# Access Compliance Report

## Public Rights-of-Way

### (Curb Ramps)

Intersection ID: 45861	Main Street: MADDOX_CT	Cross Street: HENDERSON_OAKS_DR	Location: W
ADA ID: 96536ED2F346	Ramp Type: Perp	Initial Pass/Fail: Fail	Overall Compliance: No
Severity Score: 26.25			
Codes/Mitigation Info/Possible Solution		Field Measurements/Component Compliance

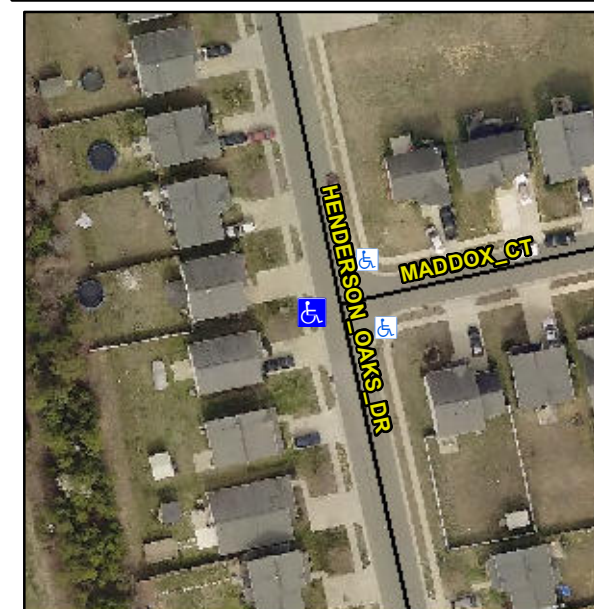
**Not Found, R304.2.2**

Compliance	Description	Data	Compliance	Description	Data
N/A	Ramp Length (in)	47.5	No	Ramp Slope (%)	16.3
Yes	Ramp Width (in)	48.0	Yes	Ramp XSlope (%)	3.2
N/A	Flare Type LT	N/A	N/A	Flare Type RT	N/A
N/A	Flare Slope LT (%)	N/A	N/A	Flare Slope RT (%)	N/A
N/A	Flare Traversable LT?	N/A	N/A	Flare Traversable RT?	N/A
N/A	Landing Length (in)	N/A	N/A	DWS Provided?	N/A
N/A	Landing Width (in)	N/A	N/A	DWS Contrast?	N/A
N/A	Landing Slope (%)	N/A	N/A	DWS Length (in)	N/A
N/A	Landing X Slope (%)	N/A	N/A	DWS Full Width?	N/A
N/A	Landing Curb? (Y/N)	N/A	N/A	DWS Offset (in)	N/A
N/A	Shared Landing?	N/A			
N/A	Gutter Ponding?	N/A	N/A	Gutter Slope (%)	N/A
N/A	Gutter Lip Ht (in)	N/A	N/A	Gutter X Slope (%)	N/A
N/A	Painted X Walk1?	No	N/A	Painted X Walk2?	N/A
	X Walk 1 Direction	To E		X Walk 2 Direction	N/A
N/A	X Walk 1 Width (in)	N/A	N/A	X Walk 2 Width (in)	N/A
	X Walk 1 Slope (%)	3.6		X Walk 2 Slope (%)	N/A
	X Walk 1 X Slope (%)	3.8		X Walk 2 X Slope (%)	N/A

**Remove & Replace Entire Ramp.**
